**MEMORANDUM**

**TO:** District of Columbia Zoning Commission

**FROM:** Jennifer Steingasser, Deputy Director Development Review & Historic Preservation

**SUBJECT:** Setdown Report: ZC 11-24, Consolidated PUD and related Map Amendment from the R-4 to C-2-B zone at Square 901, Lot 801 (former Hine Jr. High School)

**BELOW-GRADE RETAIL ALTERNATE – NORTH-SOUTH SITE SECTION D** A43a

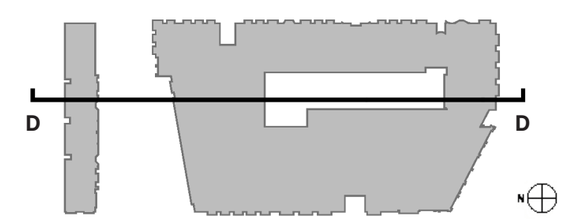
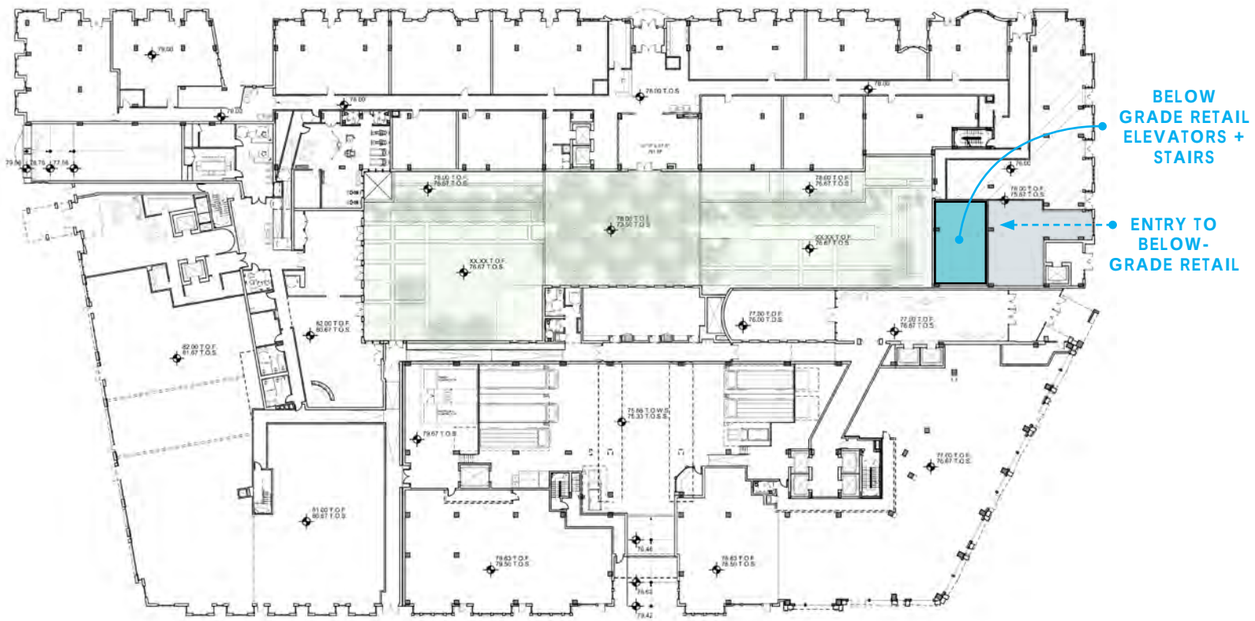
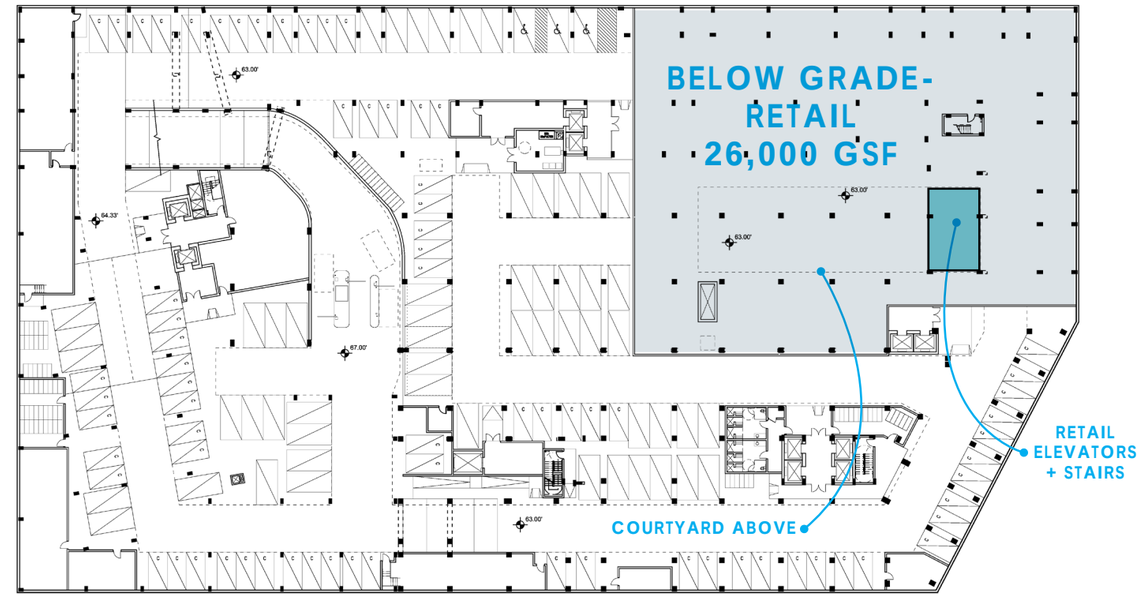
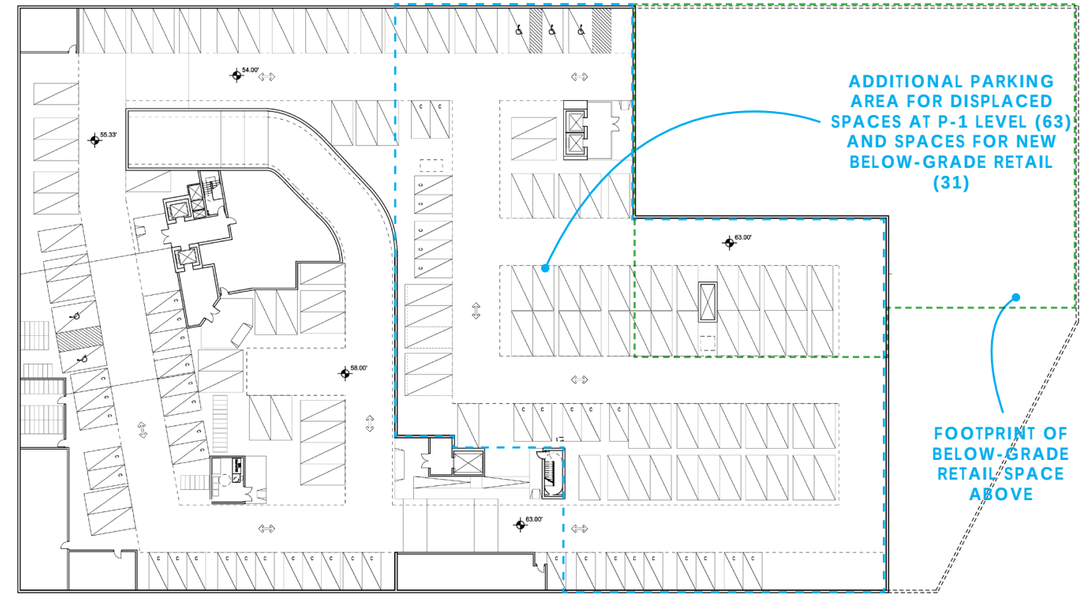
*Alternate Use*
The Applicant has requested the flexibility to replace 26,000 gross square feet of garage space on the P-1 level with a gym/health club, a medical office, a library or a grocery store (Sheet A 43). The non-parking use would result in the removal of the parking as shown on Sheet A 12 and would lead to the expansion of parking level P-2. Both parking levels would be reconfigured to accommodate the displaced spaces as well as the 31 additional spaces required to service the new space. As habitable space, it is required to have heights that are greater than that of both parking levels. Therefore, the space will occupy the P-1 level as well as a portion of the P-2 level. Access to the space will be via an elevator which is accessed from Pennsylvania Avenue. On the alternate parking layout the Applicant needs to demonstrate how patrons would access the new space from the garage.
